### **Amendments to the Drawings:**

## **R E M A R K S**

The office action of March 24, 2006, has been reviewed and its contents carefully noted. Reconsideration of this case, as amended, is requested. Claims 1-4, 12-38, and 47 remain in this case, claims 5-11, 39-46 being cancelled by this response.

In figure 1: item 16 and item 19

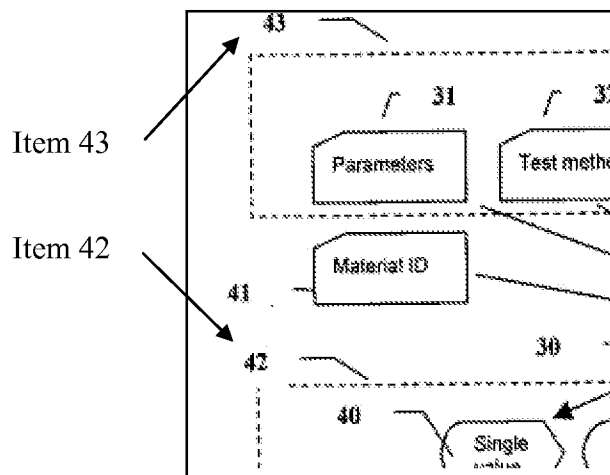
- 4. The drawings were objected to for the following reasons: (a) "that they do not include the following reference sign(s) mentioned in the description: item 16 (Fig 1); item 19 (Fig 1); item 42 (Fig 3); item 43 (Fig 3); item 73 (Fig 7); and item 74 (Fig 7)" and (b) "because they include the following reference character(s) not mentioned in the description: Fig 5 and Fig 7".

It should be noted here, however, that item 19 shown in this detail was in error, and therefore has been removed in the provided amended drawing sheet 1.

- a. In figure 1, the reference number 19 and associated line are removed.

- Item 16 has been added to page 5, third paragraph.
- Item 19 has been removed from figure 1.
- Items 42 and 43 have been added to page 7, first full paragraph.
- Items 73 and 74 have been added to page 13, third paragraph.
- An explicit reference to Figure 5 has been added to page 12, line 19.
- An explicit reference to Figure 7 has been added to page 12, line 23.
